**SERVICE BULLETIN**

**APPLICABILITY:** 2019-20MY Forester **NUMBER:** 12-298-20  
**SUBJECT:** Rear Outer Seat Belts Not Retracting Smoothly **DATE:** 10/07/2020

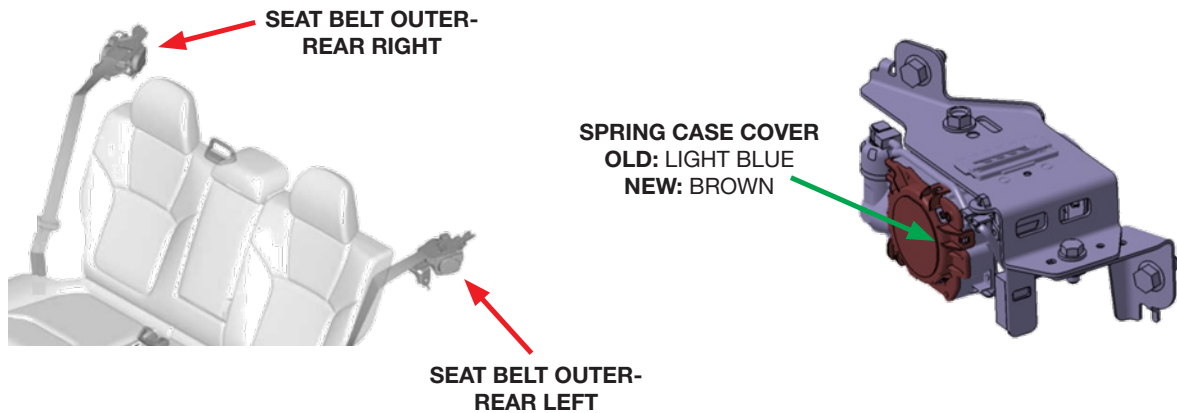
This bulletin announces a countermeasure made to the rear outer seat belt assemblies. The change was made in response to customer concerns of the seat belts not retracting smoothly. The condition is caused by insufficient rewinding force from the return spring inside the retractor mechanism. New seat belt assemblies have been developed incorporating an enhanced return spring with higher rewinding force.

**NOTE:** The new-style belt sets are easily identified by the **BROWN** spring case cover on the retractor mechanisms as shown above.

Description	Part Number
SEAT BELT-OUTER REAR RIGHT	64660SJ021VH
SEAT BELT-OUTER REAR LEFT	64660SJ031VH
